Subject: UniStar Nuclear Energy, NRC Docket No. 52-016
Submittal of Response to Request for Additional Information for the Calvert Cliffs
Nuclear Power Plant, Unit 3
RAI No. 36, Revision 0 – Emergency Planning

Response to RAI No. 36, Revision 0

Emergency Planning

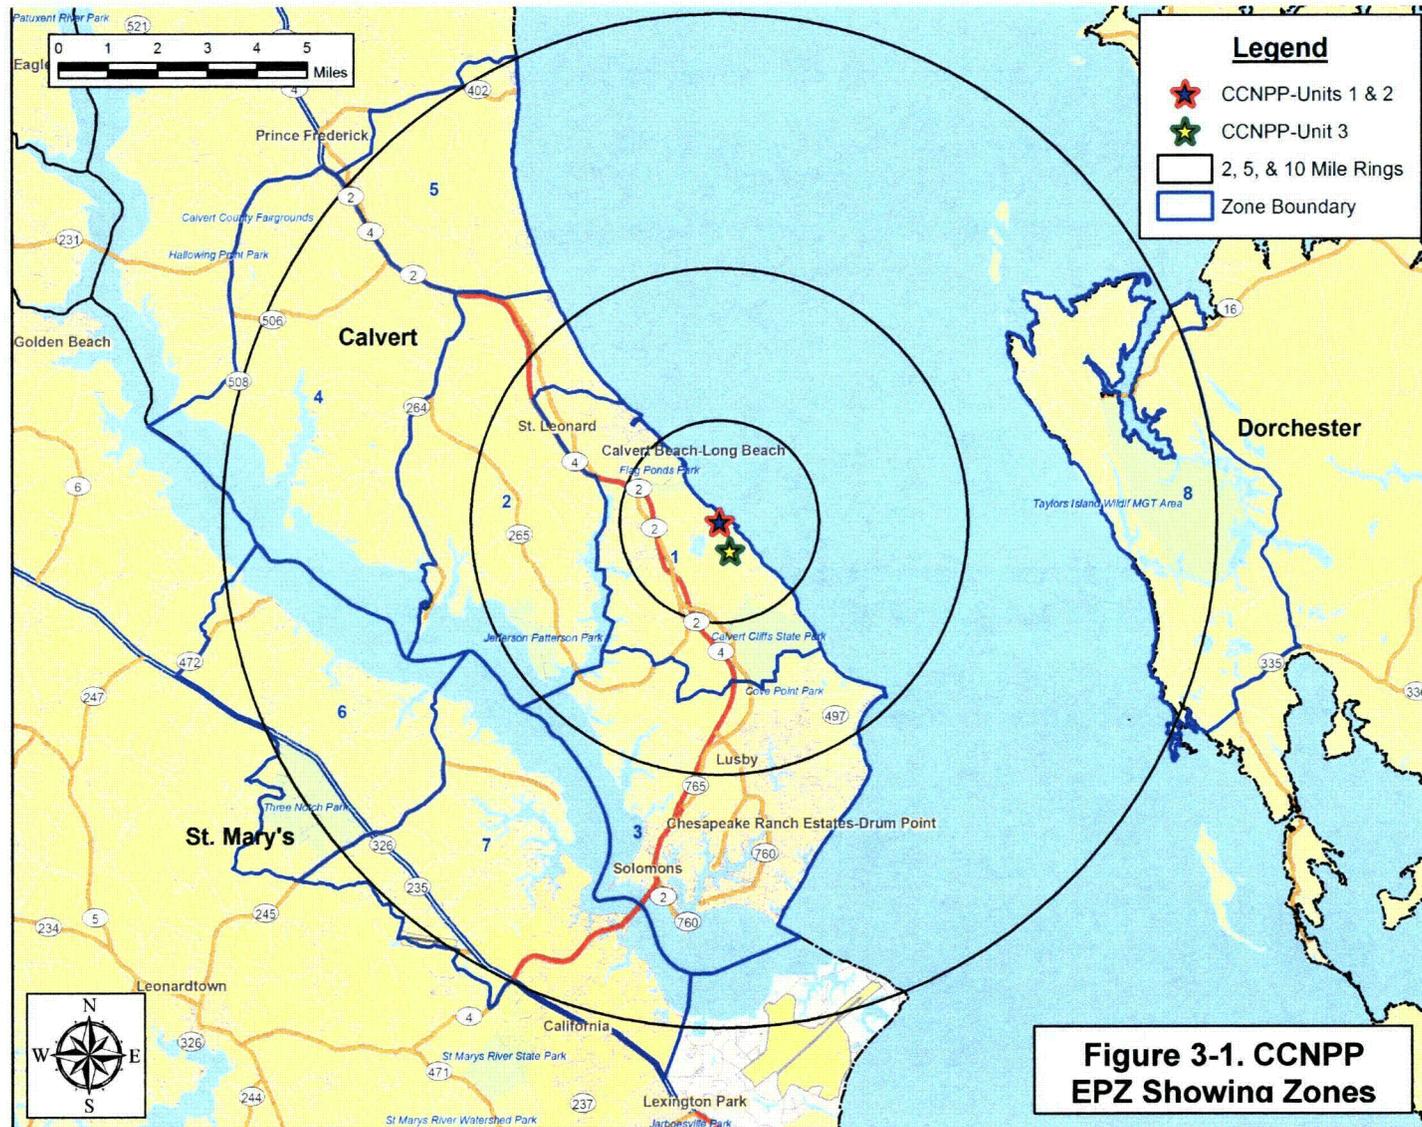
Figure 2-1, "Site Vicinity Protective Action Zones and Reception Centers Plume Exposure Pathway EPZ," (Page 2-12) provides a vicinity map of the Plume Exposure Pathway Emergency Planning Zone (EPZ) as of August 2002. Surrounding communities, political boundaries, and the location of the new unit are not identified. Provide a map that includes any information that may update the 2002 map in the ETE. This map should clearly define surrounding communities, political boundaries, and the location of the new unit.

- Figure 3-1: The eight Protective Action Zones that in aggregate form the CCNPP EPZ. The CCNPP symbol identified on the map in the report is the midpoint of the coordinates for CCNPP Units 1 and 2. The attached map also identifies the proposed coordinates of CCNPP Unit 3; this map will replace Figure 3-1 in a future revision of the ETE report. County boundaries and major communities are identified in the map.

Figure 3-1 of the ETE report (Enclosure 2) will be replaced with the attached figure in a future COLA revision.

Figure 7-3. Congestion Patterns at 1½ Hours after the Evacuation Advisory – Scenario 1, Full EPZ

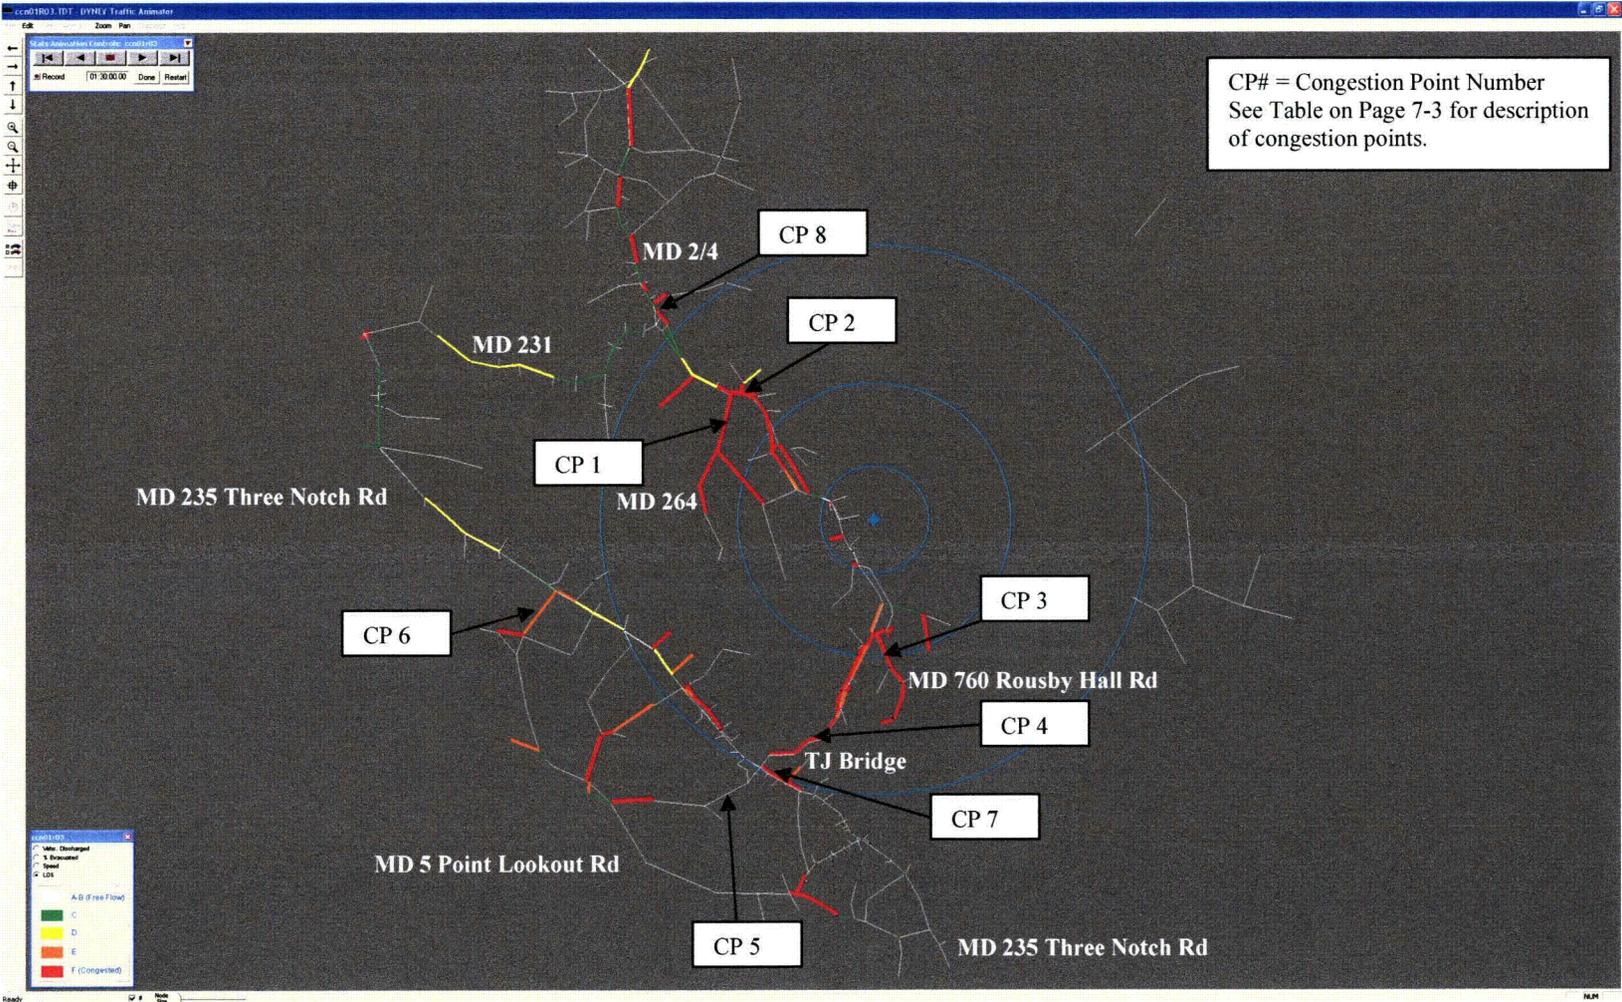
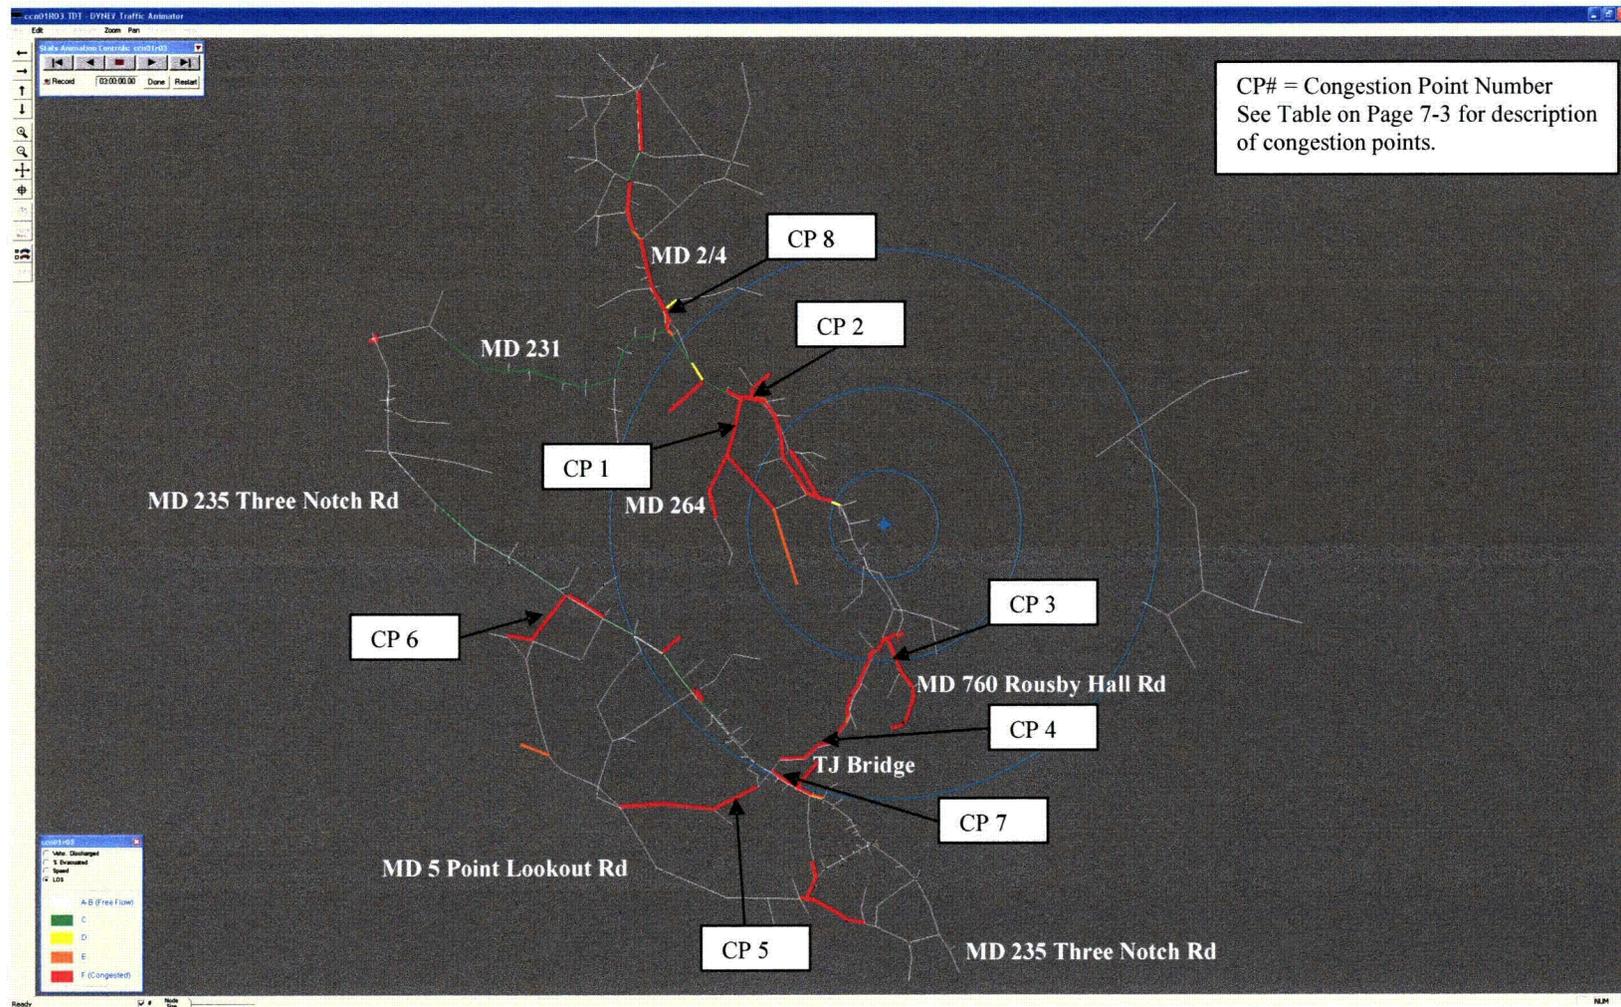
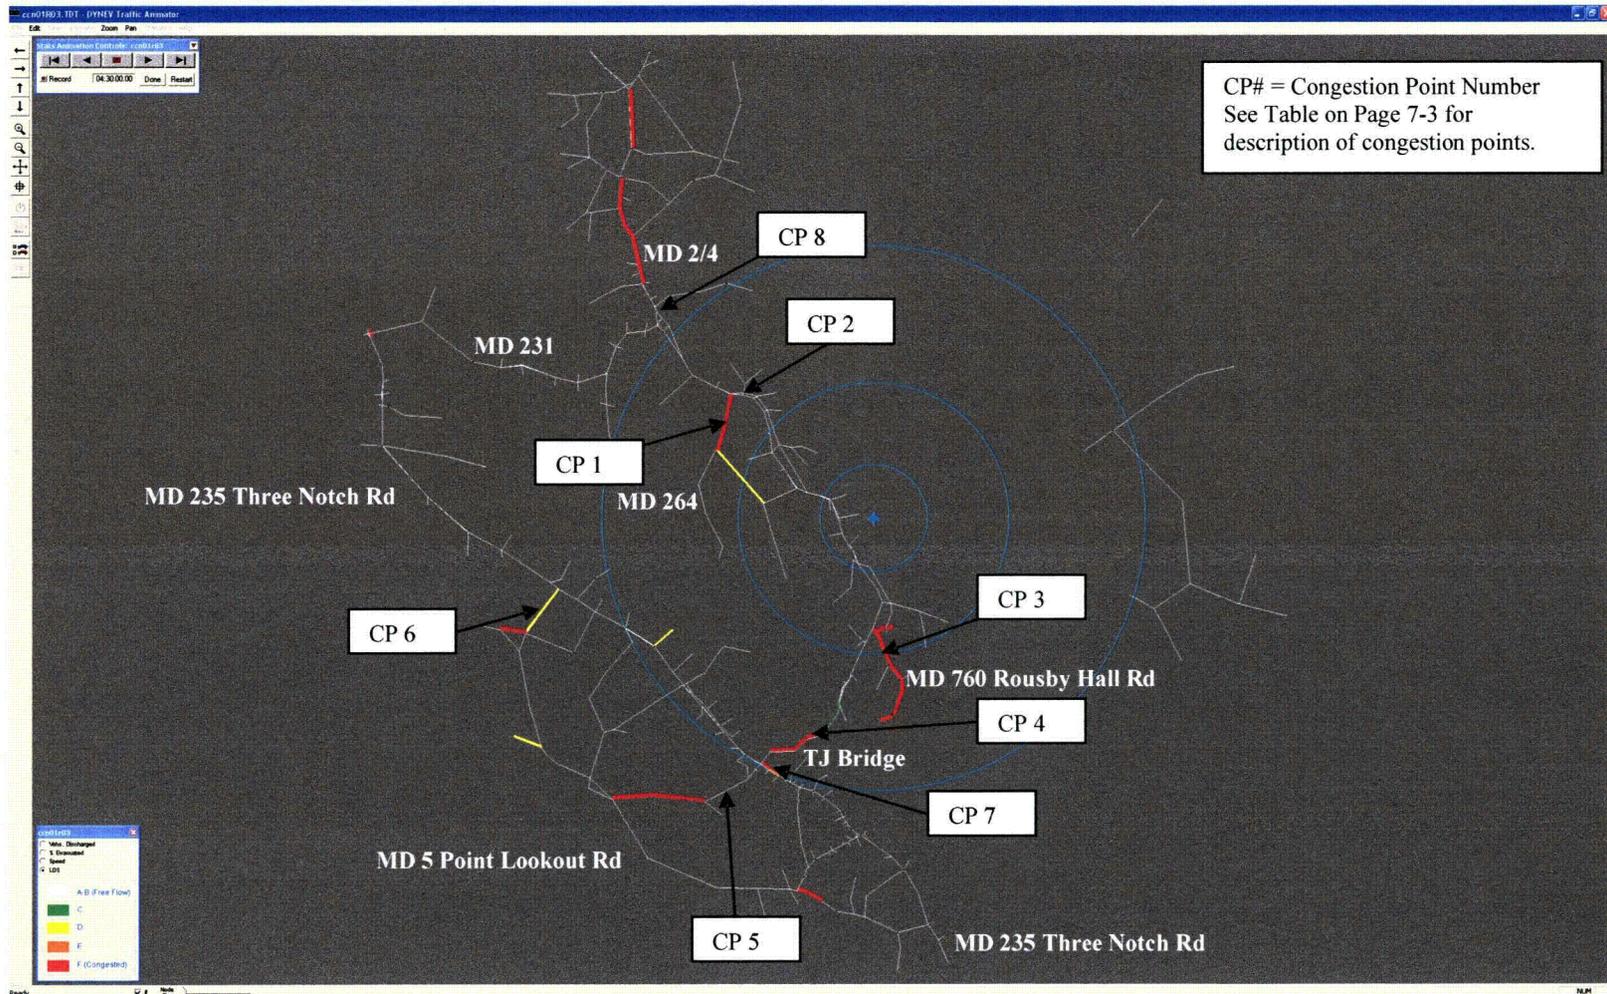
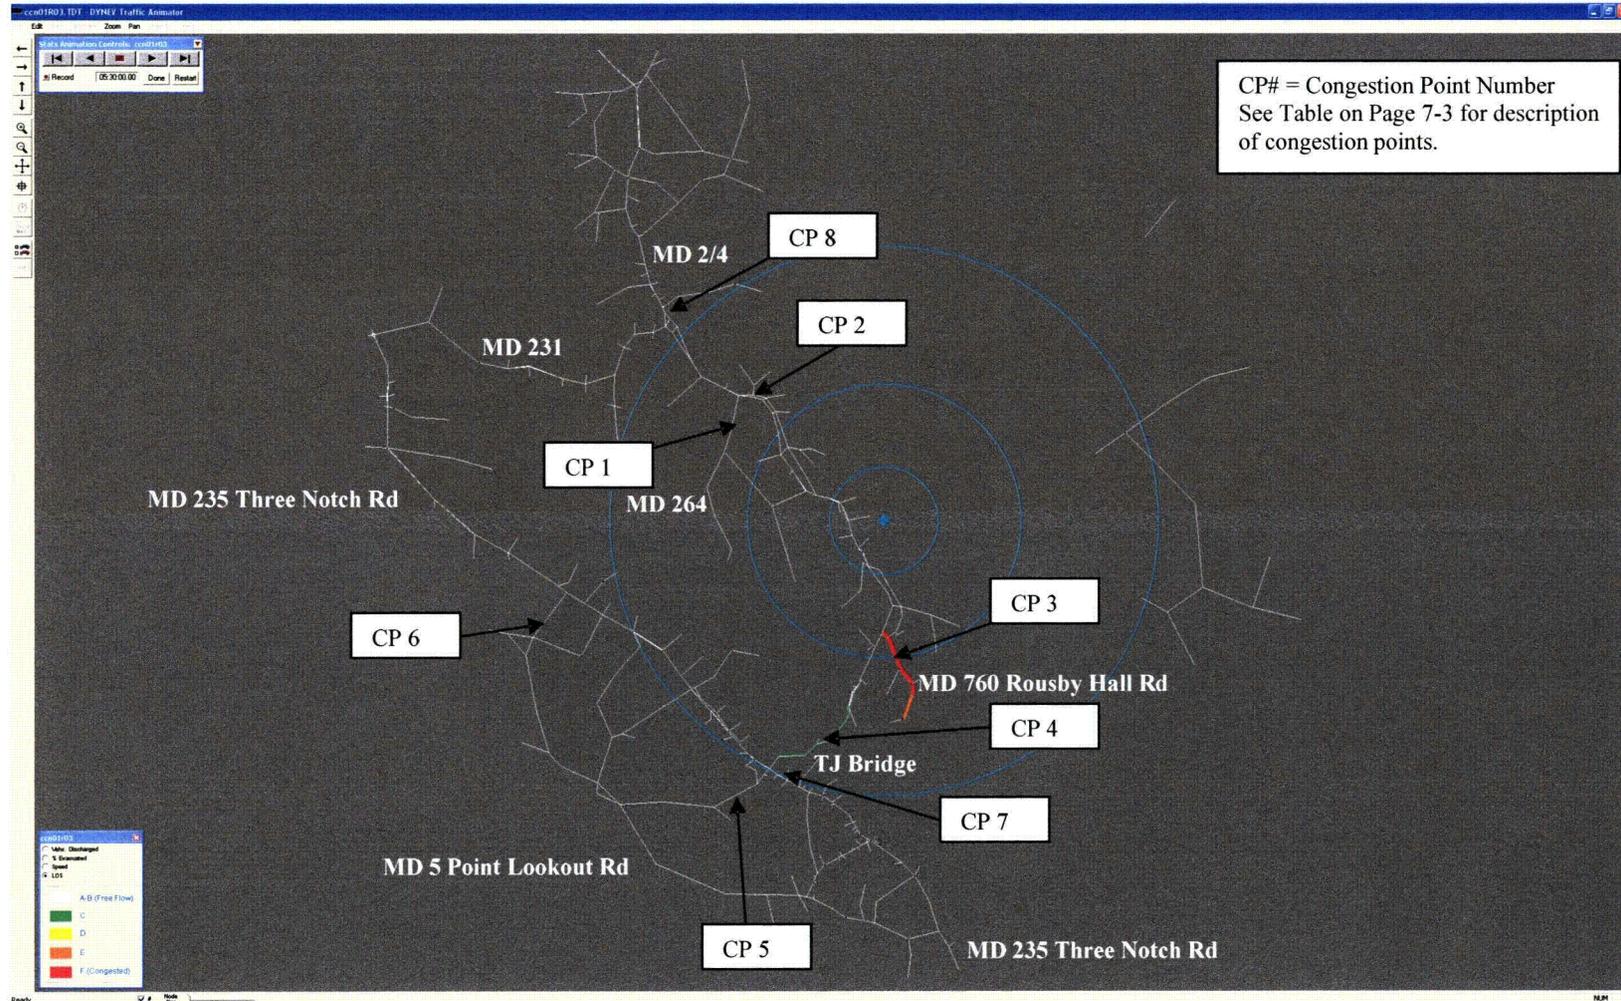
D. Figure 7-1, "Recommended Traffic control," (page 7-3) points out an area of congestion on the Thomas Johnson Bridge at the South of the plant. According to the MD 4 - Thomas Johnson Memorial Bridge Planning Study^[1], (pages 1-7) congestion on Thomas Johnson Memorial Bridge is problematic. All intersections have a failing Level of Service (LOS) in both the AM and PM peak hours. This information agrees with the findings in, "St. Mary's County Transportation Plan^[2]," which identifies a need to widen Maryland Route 4 and add an additional span to the Thomas Johnson Bridge to accommodate existing conditions and anticipated growth. The current situation with traffic congestion on Maryland Route 4 and the Thomas Johnson Bridge is not addressed in the ETE. Provide additional information on potential traffic congestion associated with the Thomas Johnson Bridge and Maryland Route 4 during evacuation scenarios.

D. Section 7.2 of the 2008 ETE report discusses the patterns of traffic congestion during evacuation. The text indicates that there is pronounced congestion southbound on Maryland Route 2/4, especially in the area of the Thomas Johnson Bridge. Figures 7-3 through 7-6 provide screen captures from EVAN (Evacuation Animator) which show the level of service (LOS) on all links in the analysis network at that time. The links are color coded according to LOS, with those links experiencing LOS F (congested) colored red and those experiencing LOS A (free-flow) colored white. As Figure 7-5 indicates, congestion on the Thomas Johnson Bridge persists until 4½ hours after the advisory to evacuate, while congestion on Rousby Hall Road extends to almost 6 hours.

Based on guidance provided in NUREG-0654, revised versions of Figure 7-3 through 7-6 (attached to this response) were created, which identify the major roads in the analysis network and the major congestion points. The attached table summarizes the delay (minutes/vehicle) at each of the congestion points over the 10-minute period preceding the indicated elapsed time from the advisory to evacuate. This table and the revised Figure 7-3 will be included in Section 7 of a future revision of the ETE report.

The following updates will be provided in a future revision of the CCNPP Unit 3 COLA: 1) the attached table "Average Delay for Selected Roadways in the CCNPP EPZ" will be inserted on page 7-3 of the ETE report, before the beginning of Section 7.3, 2) ETE Report Figures 7-3 through 7-6 will be replaced with the attached versions of these figures, and 3) the ETE report will incorporate the information cited in the response to item D of this question.
